Re: Florida Power & Light Company
Proposed Turkey Point Units 6 and 7
Docket Nos. 52-040 and 52-041
Voluntary Submittal of Exemption Request and Design Change
Description for Departure from AP1000 DCD Revision 19 to Address
Compliance With IEEE 603-1991

**FPL Voluntary Submittal
Source Range Neutron Flux Doubling Block Permissive
Turkey Point Units 6 & 7 COL Application**

**Request For Exemption Regarding
IEEE 603-1991 Compliance**

Figure 7.2-1 (Sheet 3 of 21)

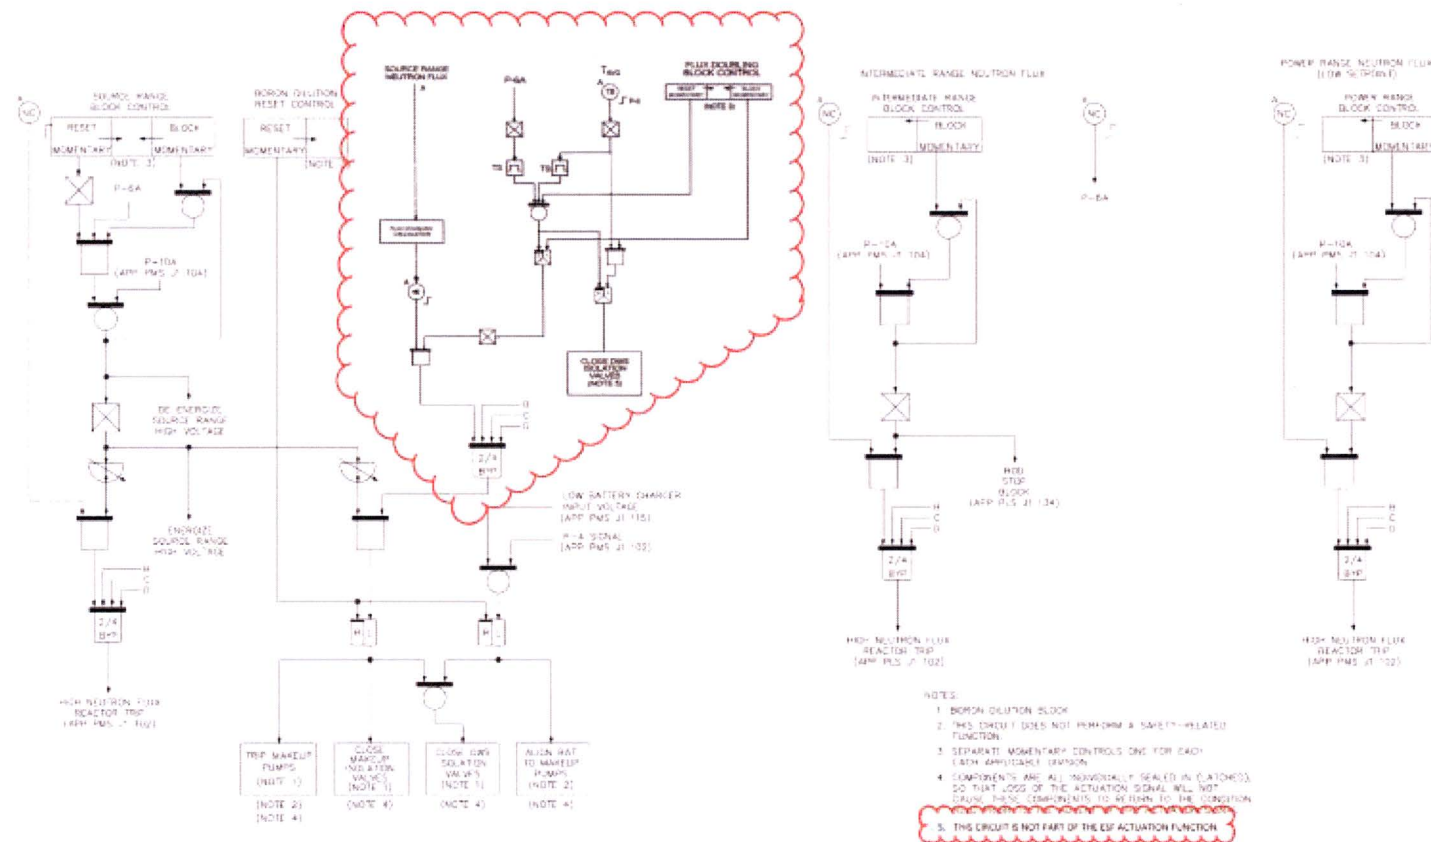
- Figure 7.2-1 (Sheet 3 of 21); Add logic for condition when source range flux doubling signal may be manually blocked and automatically reset.
- Section 7.3.1.2.14, Boron Dilution Block; Revise discussion of conditions when the source range flux doubling signal may be manually blocked and when it is reinstated.

PTN DEP 7.3-1

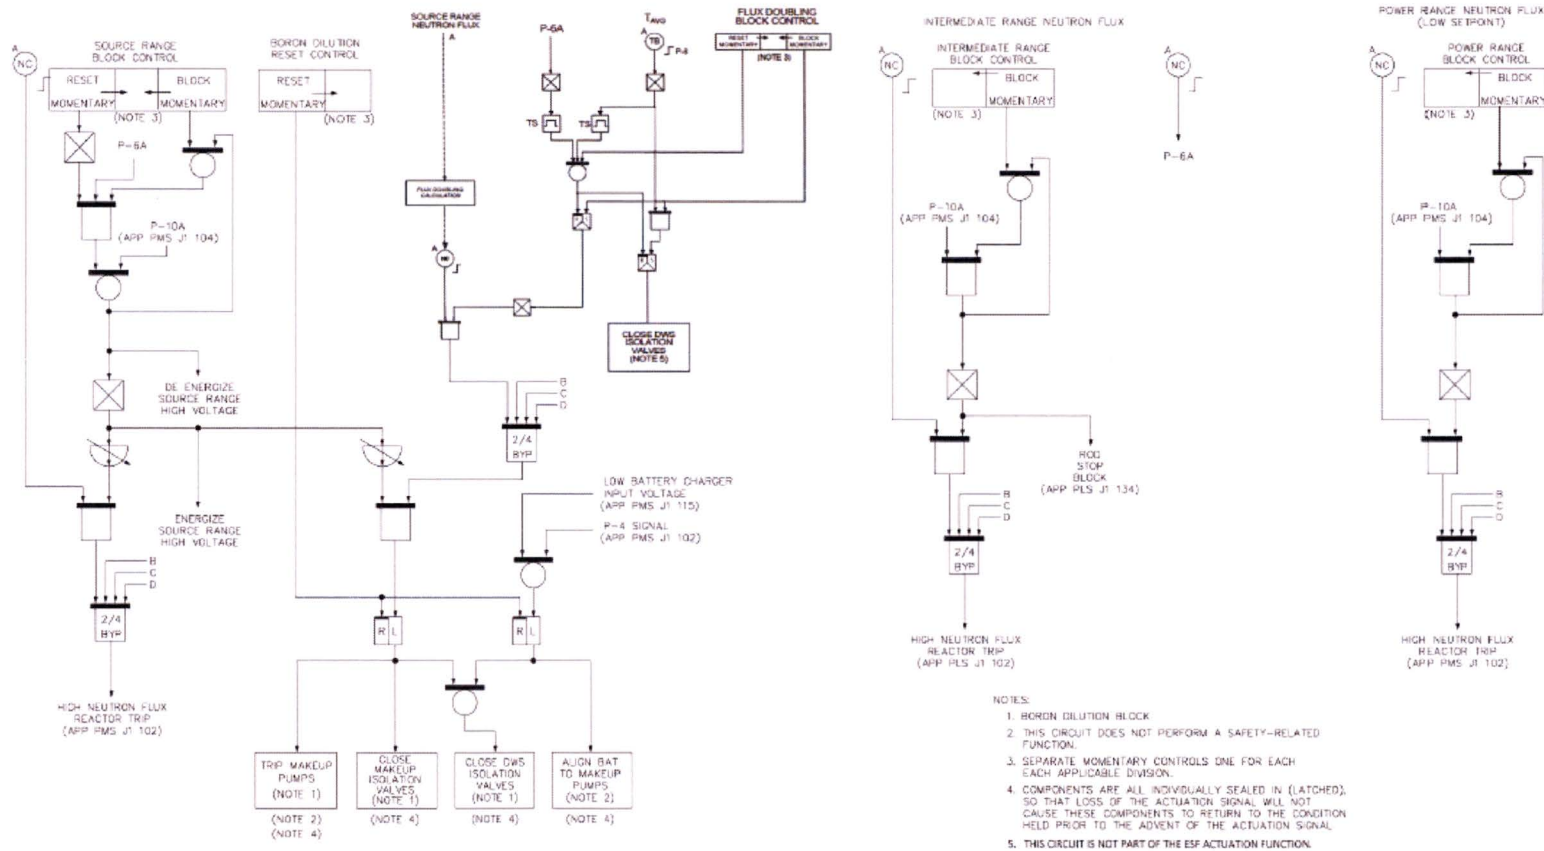
2.. COLA Part 2, FSAR Chapter 7 is revised with the addition of Figure 7.2-1R with annotation PTN DEP 7.3-1 as follows (departure from DCD Figure 7.2-1 (Sheet 3 of 21):
